Orderable: ChangeMe in variant	Designed for: Public Release	Mod. Date: 3/29/2022
TID #: N/A	Project Title: Change in menu Project	Project Options Parameter
Number: Cascode TPSI3050 E1	Sheet Title:	
SVN Rev: Not in version control	Assembly Variant: 001	Sheet: 2 of 3
Drawn By:	File: BlankSheet.SchDoc	Size: B
Engineer: Francisco Lauzurique	Contact: http://www.ti.com/support

PCB Number: Cascode_TPS13050
PCB Rev: E1

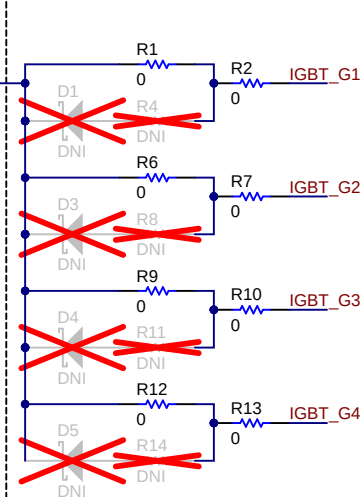
Gate Resistors / Split out

Vdrive SEL

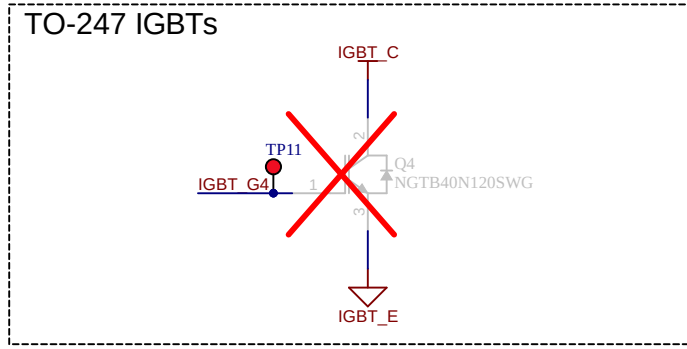
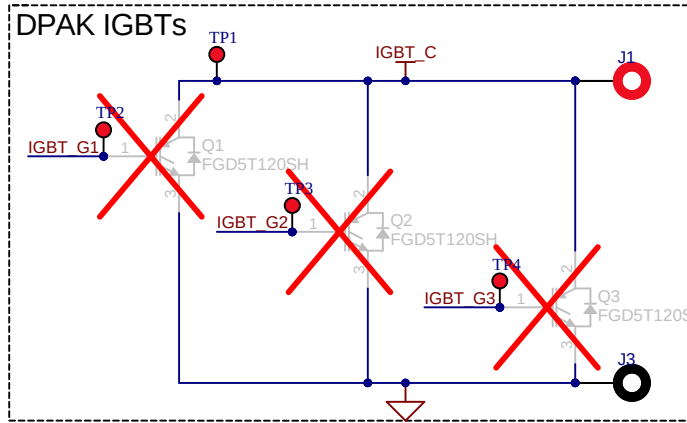
Jumper for Lower only. Add same for U1?

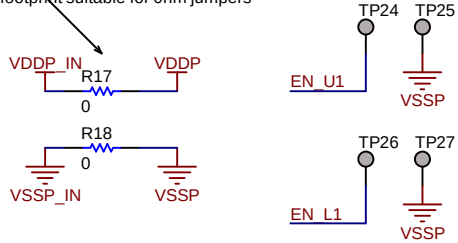
Optional CMC, make footprint suitable for 0hm jumpers
